Matela, Nancy, Commenter ID No. E68

Greater-Than-Class-C Low-Level Radioactive Waste EIS Draft Comment: GTCC10150

W517-1

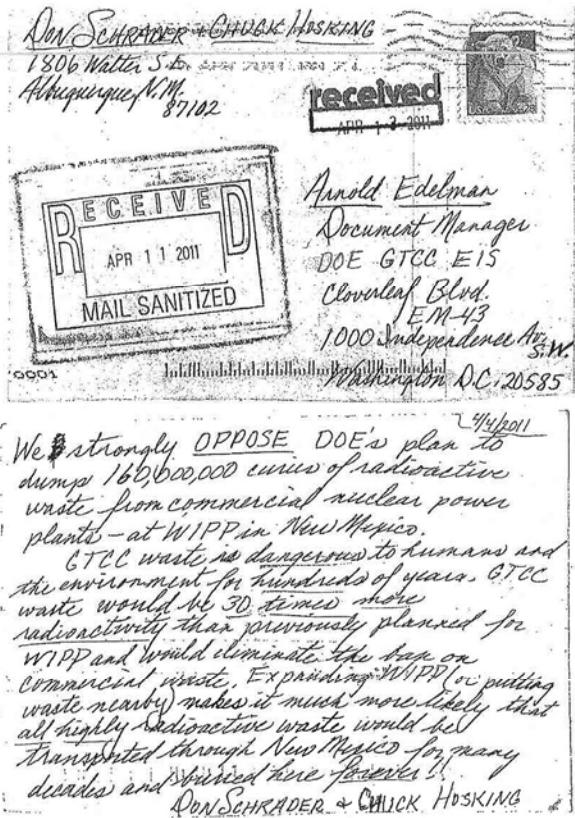
Comment Submitted:
 Please DO NOT allow any nuclear waste to be transported through Oregon. Hanford is already a very contaminated site, and the wastes in existing soil trenches and ditches and from tank leaks need to be removed, not added to! Extremely radioactive wastes belong in deep underground repositories, not in landfills, boreholes or vaults. The Columbia River is being poisoned by nuclear waste and Hanford must be cleaned up. Please do not deposit any more nuclear waste at Hanford, or transport any through Oregon.
 Thank you very much!

W517-1 DOE's ROD 78 FR 75913 dated December 13, 2013, stated that DOE has deferred a decision on importing waste from other DOE sites (with limited exceptions as described in the Settlement Agreement with Ecology) for disposal at Hanford at least until WTP is operational. For information on DOE's preferred alternative see GTCC EIS Chapter 2.
